Following this incident, SA Health commissioned Aurecon, a Professional Service Contractor (Engineering), to undertake a comprehensive and independent post-incident review of the performance of the F.M.C. emergency stand-by power system.

**Flinders Medical Centre  
Standby Power Electrical Systems  
Post-incident Review  
SA Health**

**1 November 2016  
Revision: 2  
Reference: 253946**

FMC emergency power systems (simplified)

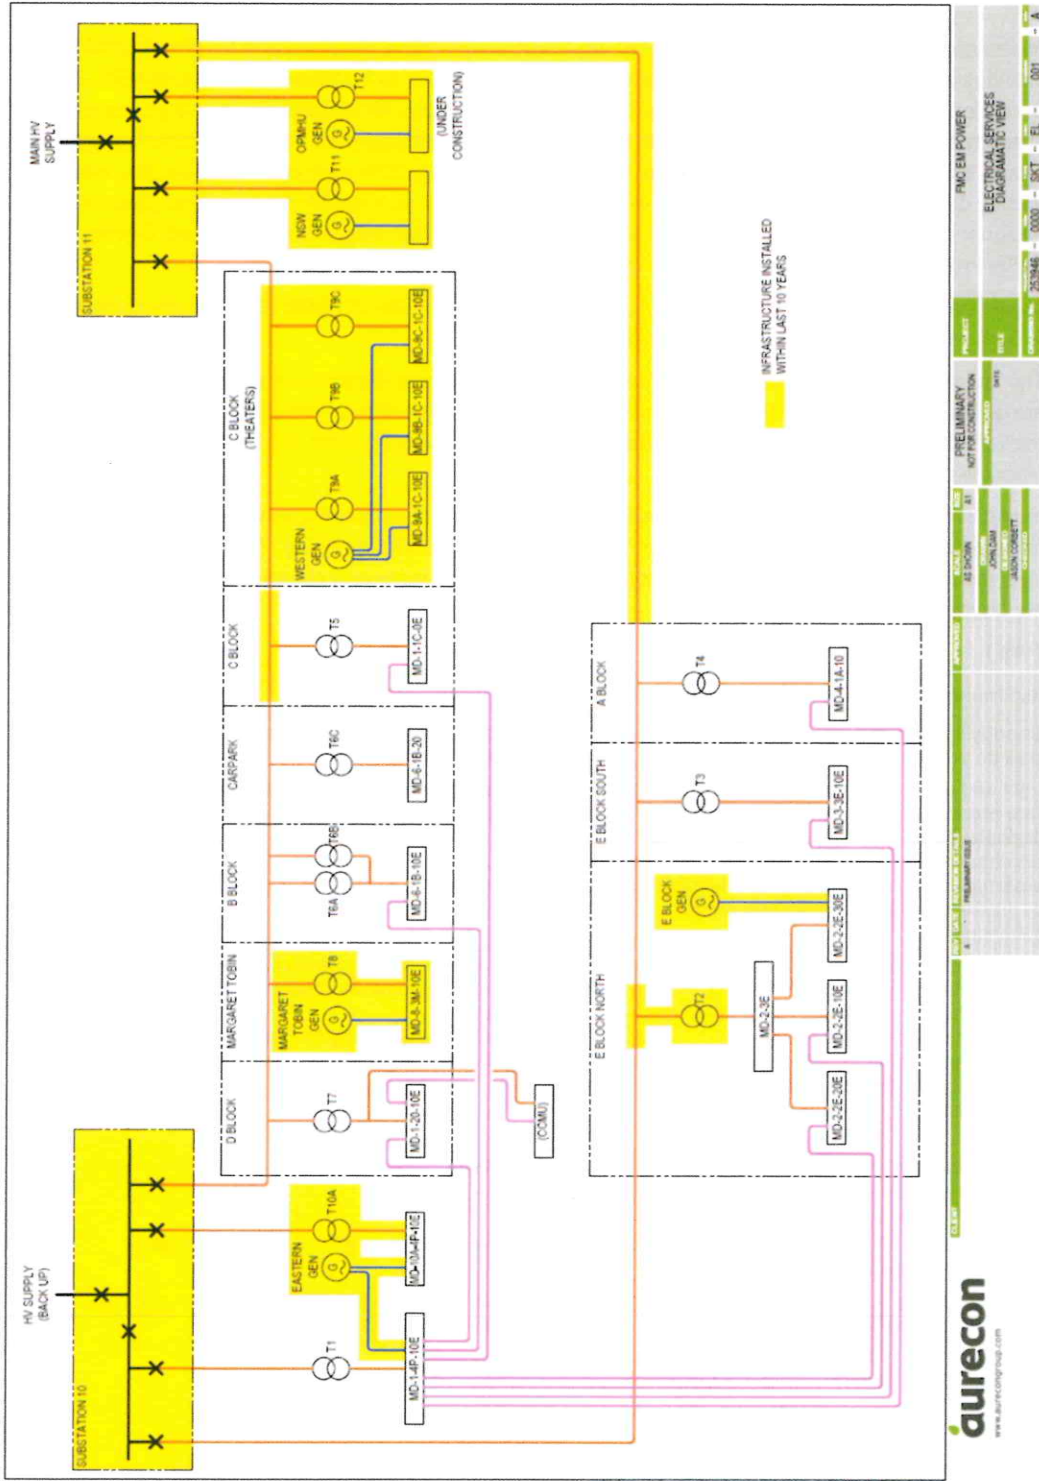
The power infrastructure at FMC provides three main levels of power supply. Refer to diagram below for a simplified view of the system. Detailed technical drawings and reports are available for further review if required.

- Primary High Voltage (HV) – this is a dedicated SA Power Networks (SAPN) 11 kV underground feeder from Seacombe substation. This supply and associated substation within FMC were constructed in 2008/9.

- Backup HV – this is a shared SAPN 11 kV feeder from Tonsley Park substation. It has available capacity to support full operation of FMC. The incoming feeder cables were replaced in 2000, and the associated substation within FMC was constructed in 2008/9. The FMC power system is arranged to automatically switch from the primary to the backup HV supply on loss of the primary supply.

- Generators. There are 5 generators at FMC (plus one for FCIC). Generators supply essential circuits only, consequently, when operating on generator there is some impact on hospital operations:

- “Eastern” (or “main”) generator supplies emergency power to the majority of the hospital. The essential supply is derived from Transformer 1 if it has power, or from the generator, and distributed to back up the main supply serving blocks A, B, C (except theatres), D, E (except certain critical engineering plant). Located externally adjacent to the main plant building and installed in 2008/9.
